UNITED STATES PATENT AND TRADEMARK OFFICE

APPLICATION NO.	FILING DATE	FIRST NAMED INVENTOR	ATTORNEY DOCKET NO.	CONFIRMATION NO.
10/517,928	12/14/2004	Peter Eichhorst	EICHHORST - 1 PCT	6882
25889	7590	09/25/2007		
WILLIAM COLLARD COLLARD & ROE, P.C. 1077 NORTHERN BOULEVARD ROSLYN, NY 11576			EXAMINER VU, QUYNH-NHU HOANG	
			ART UNIT 3763	PAPER NUMBER
			MAIL DATE 09/25/2007	DELIVERY MODE PAPER

Office Action Summary

DETAILED ACTION

Fig. 1a

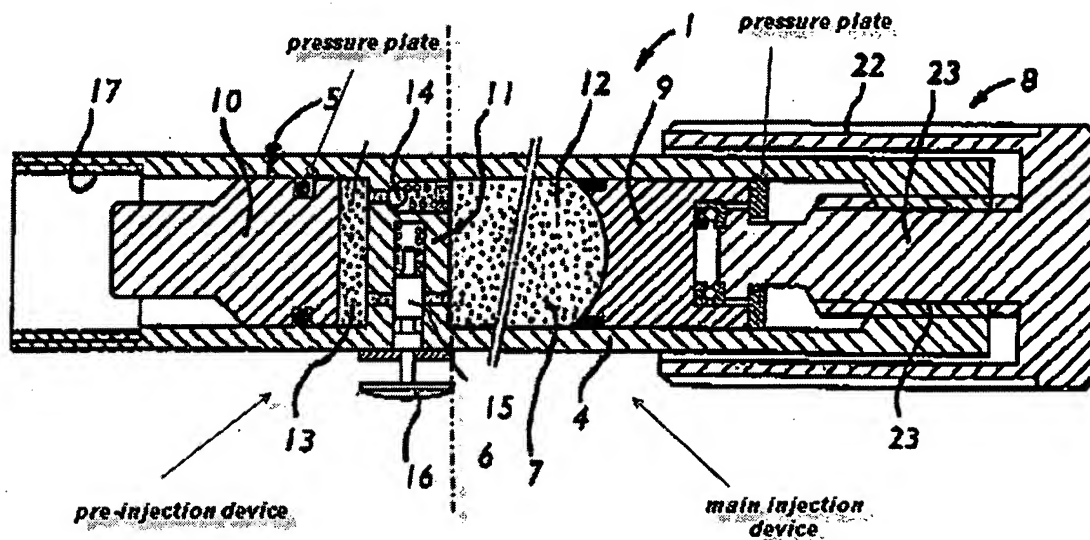
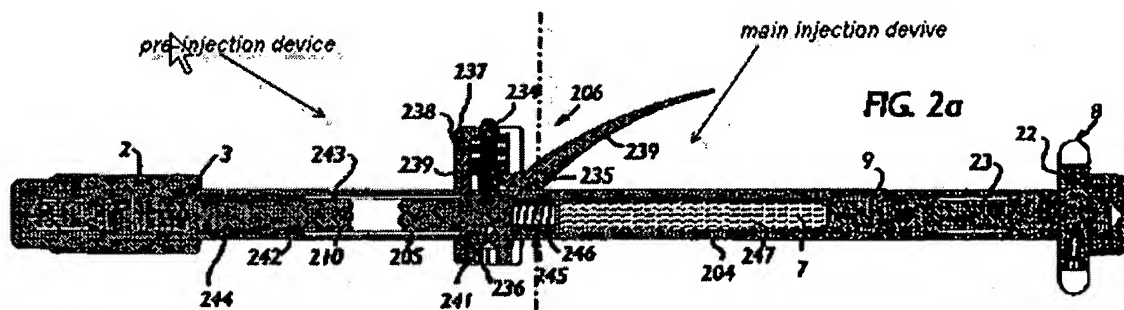
Regarding claim 8, a valve 14 or 15 is disposed within the channel (see Fig. 1a below).

Regarding claims 9-10, a trigger 16 holds a pressure plate biased by a spring (see Fig. 1a below); or a trigger 239 holds a pressure plate 234 biased by a spring 238 (see Fig. 2b below); and a trigger is connected with the chamber 2.

Regarding claim 12, the channel 4 has a connection with the chamber 13, and the valve 14 or 15 is disposed between the connection and the coupling device (Fig. 1a)

Regarding claim 13, the chamber 4 has a piston 9 or 10 that rests against the pressure plate (Fig. 1a).
